To: Prospective Offerors

RE: **Addendum No. 2**, to Design RFP954600-01, ATOD Server Room Pre-Action Clean Agent System

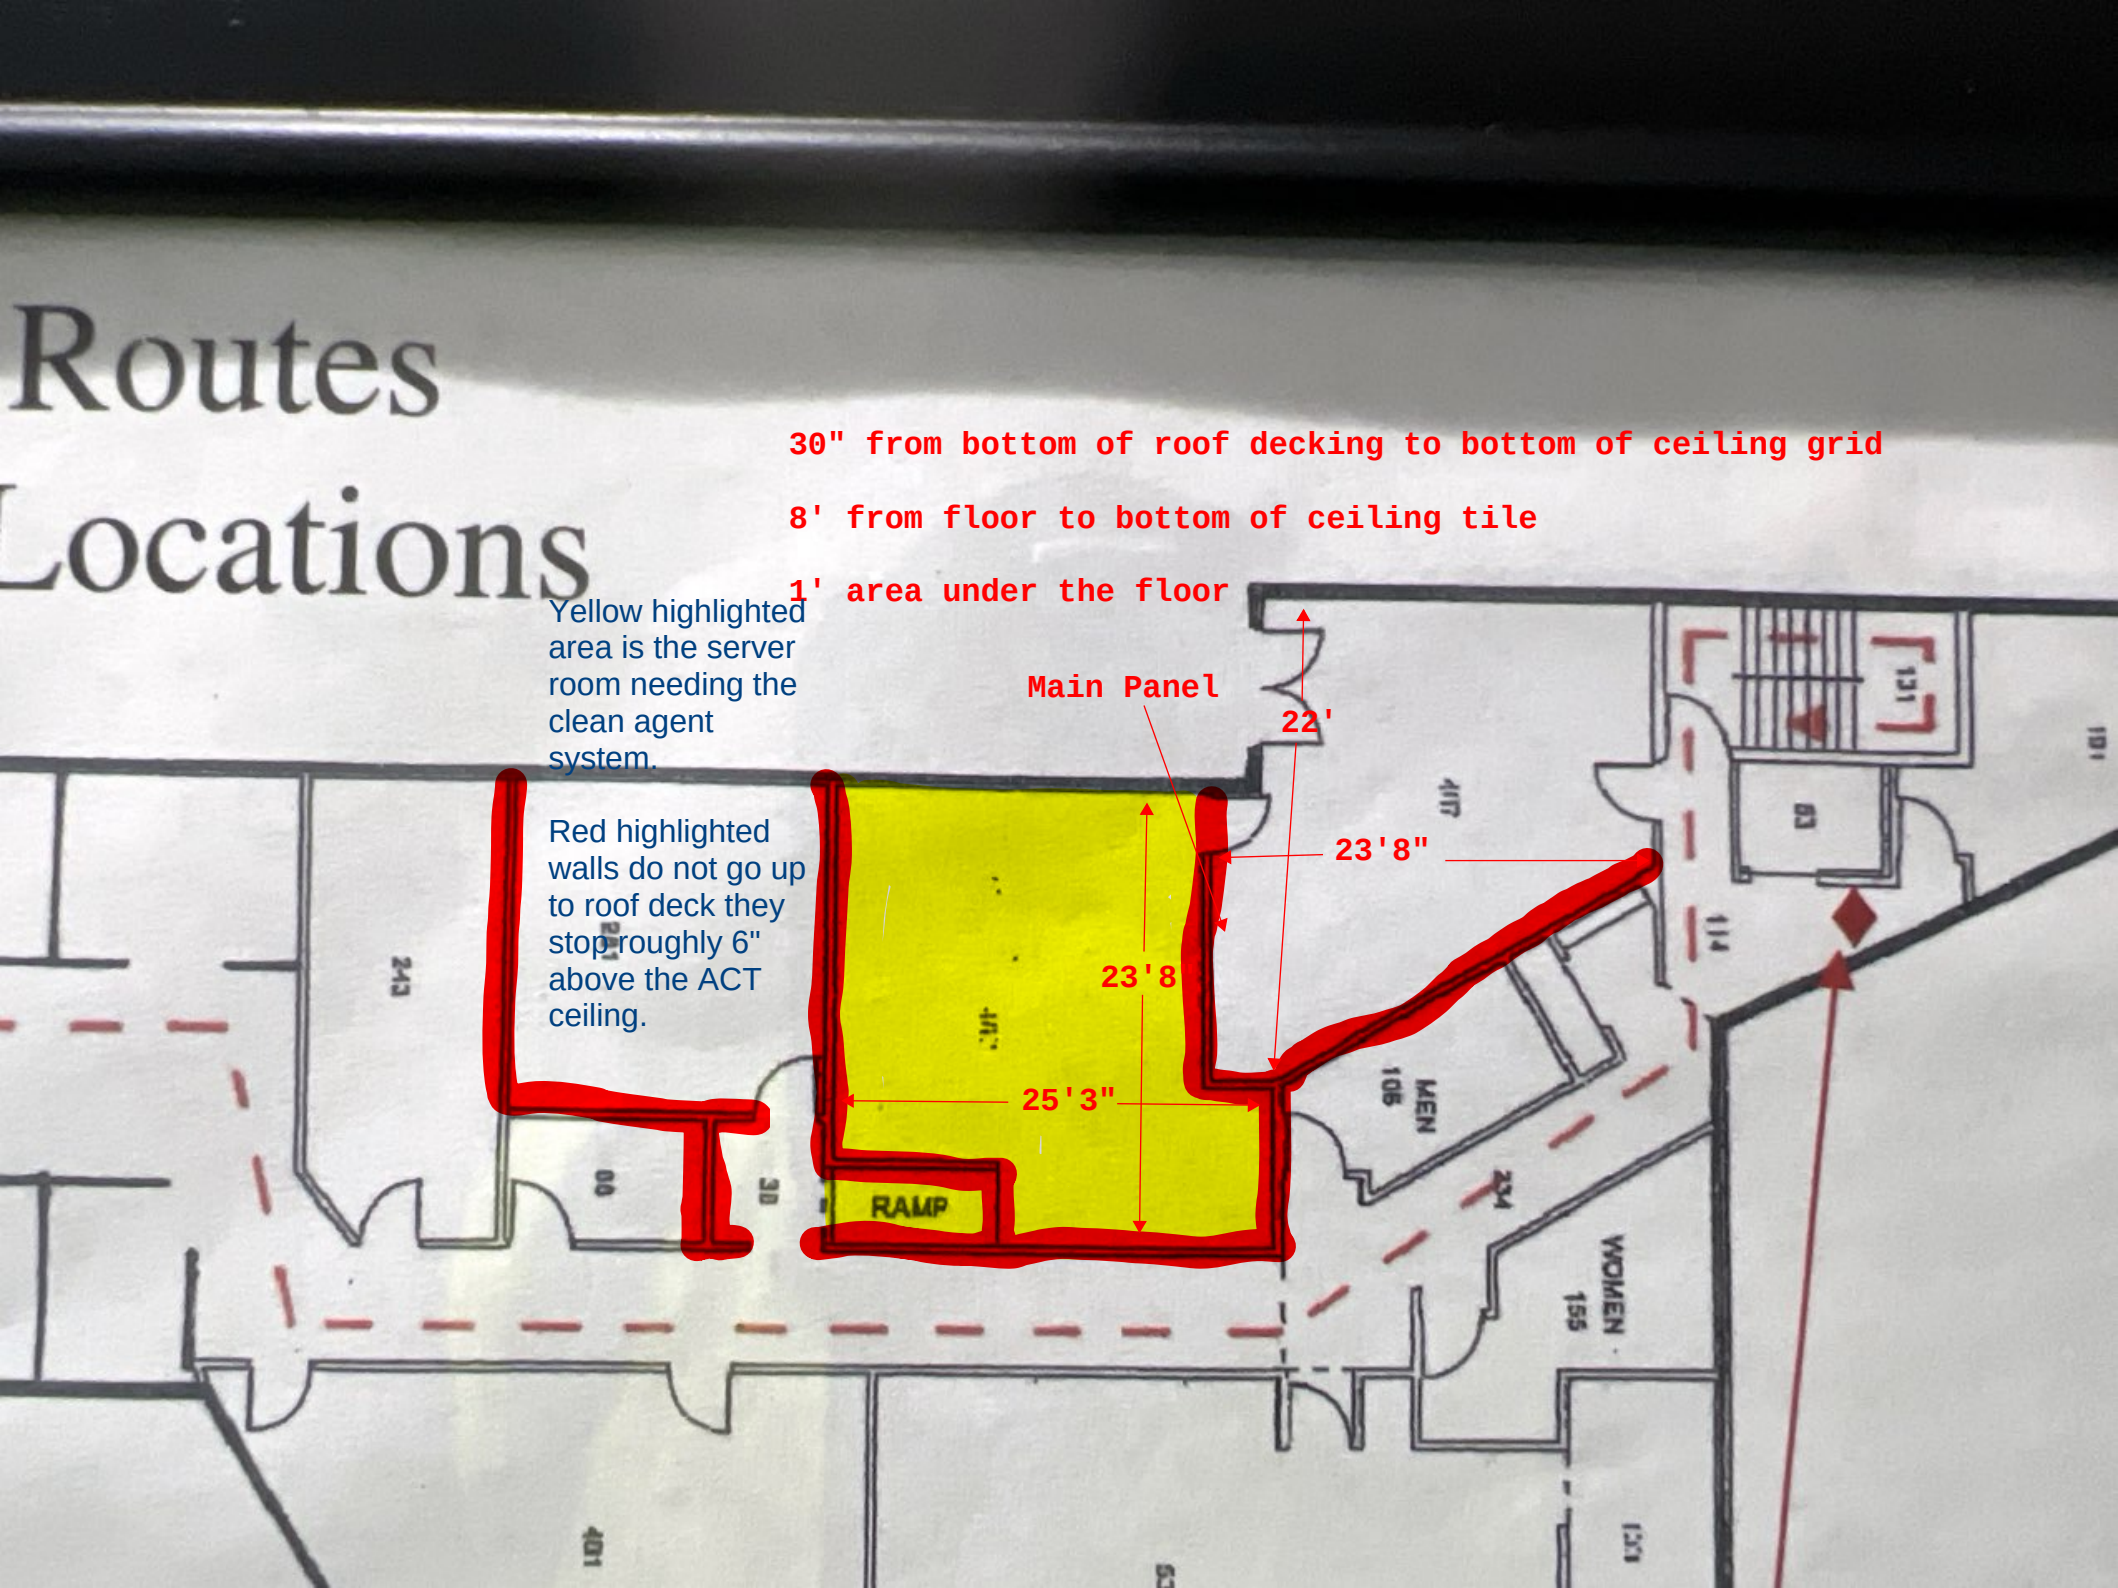
10) Do the adjacent walls go up to the roof deck?
    a. No. The adjacent walls stop roughly 6" above the ACT ceiling. The server room, adjacent storage closet & adjacent room 215 would be considered an open space above the ACT ceiling. See the updated drawing depicting this information as an attachment.

Routes
Locations
30" from bottom of roof decking to bottom of ceiling grid
8' from floor to bottom of ceiling tile
1' area under the floor
Yellow highlighted area is the server room needing the clean agent system.
Red highlighted walls do not go up to roof deck they stop roughly 6" above the ACT ceiling.
Main Panel
22'
23'8"
23'8
25'3"
RAMP
MEN
106
WOMEN
155
243
131
101
114
234
